**UNITED STATES
NUCLEAR REGULATORY COMMISSION**
WASHINGTON, D.C. 20555-0001

FACILITY: Diablo Canyon Power Plant, Unit Nos. 1 and 2

SUBJECT: SUMMARY OF JULY 11, 2012, TELECONFERENCE MEETING WITH PACIFIC GAS AND ELECTRIC COMPANY ON DIGITAL REPLACEMENT OF THE PROCESS PROTECTION SYSTEM PORTION OF THE REACTOR TRIP SYSTEM AND ENGINEERED SAFETY FEATURES ACTUATION SYSTEM AT DIABLO CANYON POWER PLANT (TAC NOS. ME7522 AND ME7523)

Figure 1 DCPD 120 Volt Vital Instrument AC System (Simplified)**Legend:**

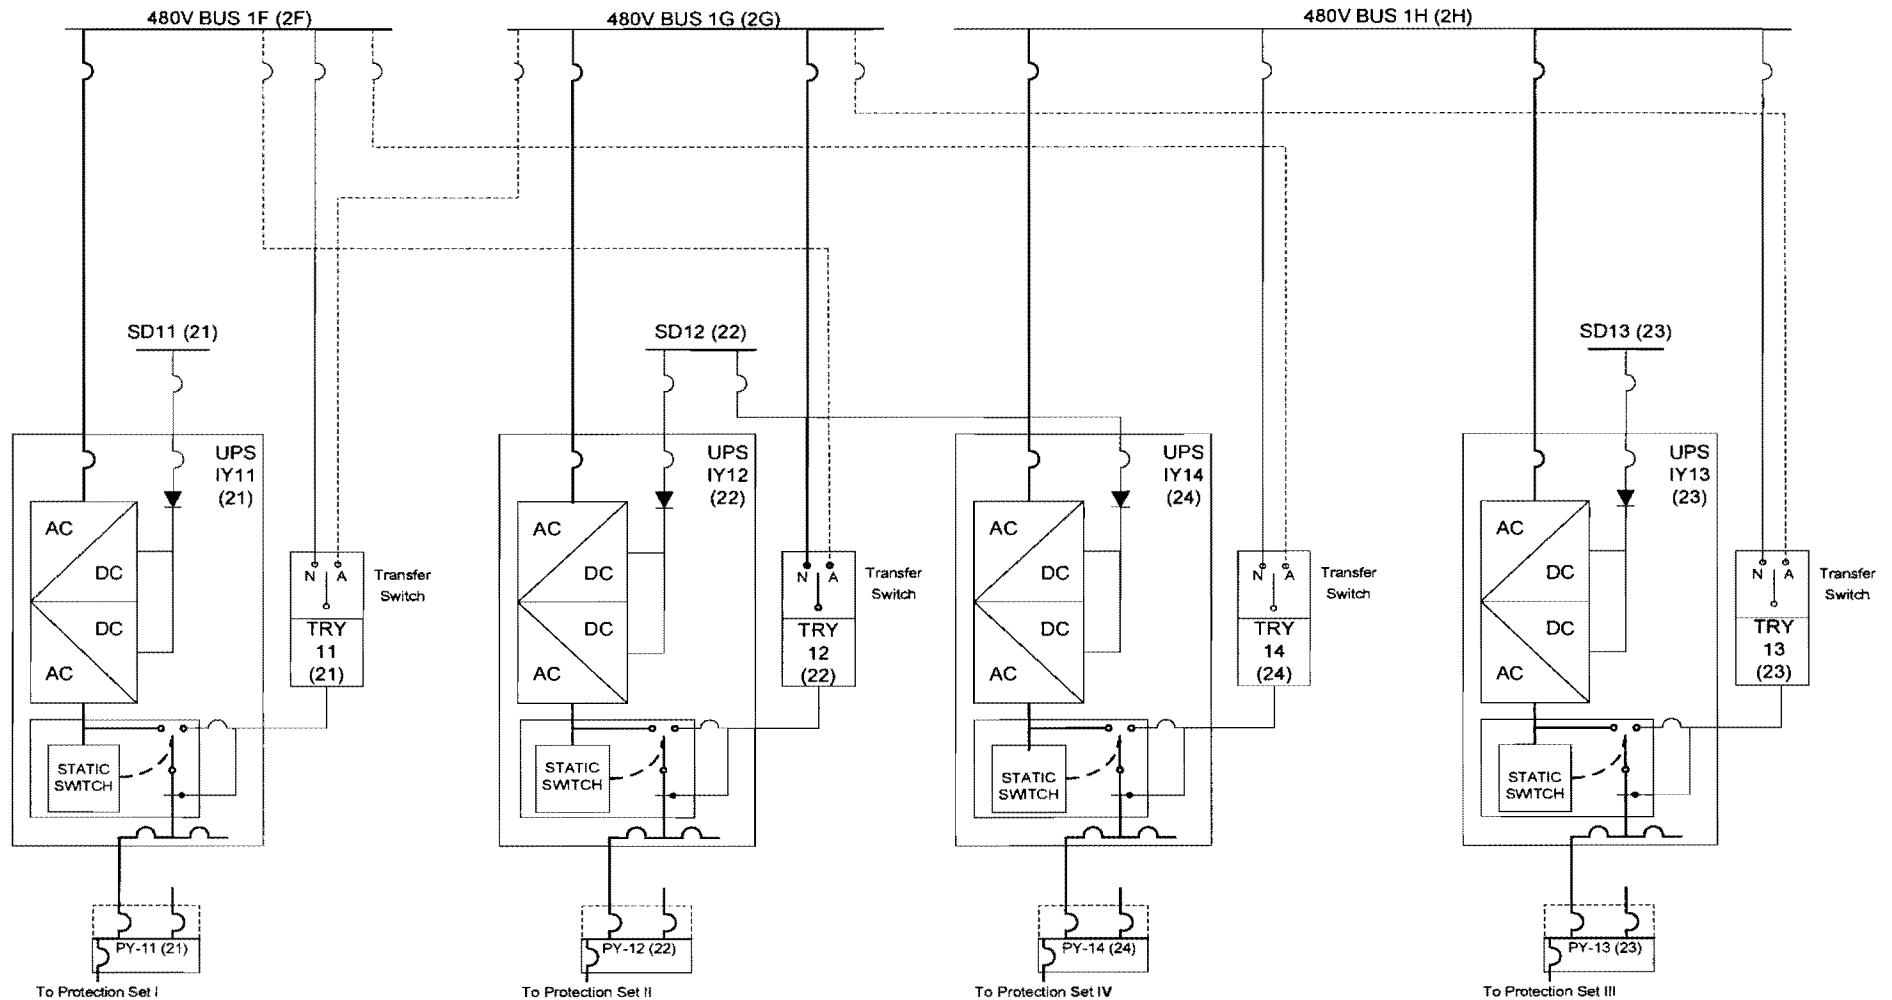
No	Src/RI	Issue Description	P&GE response:	Status	RAI No. (Date Sent)	RAI Response (Due Date)	Comments
		<p>PG&E response:</p> <p>The following description clarifies the 120 V vital instrument AC power supply to the PPS:</p> <ol style="list-style-type: none"> 1 Safety-related 480 VAC from vital AC motor control center (MCC) is fed to the UPS and rectified. 2 Rectifier output is fed to the inverter and converted to 120 VAC. 3 Safety related vital DC bus power is fed to UPS as immediate backup supply. The vital DC bus is backed up by the safety-related 125 VDC station battery, which is charged from vital 480 VAC. 4 Inverter output is fed through a static switch with integral manual bypass switch to vital instrument AC power distribution panels. 5 On loss of inverter output, the static switch will select backup regulating transformer output (120 VAC) to distribution panels. 6 The backup regulating transformer receives input from the 480 VAC supply. The backup regulating transformer may be aligned via a transfer switch to either of two 480 VAC busses; the normal supply or an alternate supply. The alternate supply circuit breaker is normally open to prevent interconnection of redundant power supplies due to a failed transfer switch. The transfer switch may not be used under load. <p>Refer to the attached block diagram for additional detail.</p>
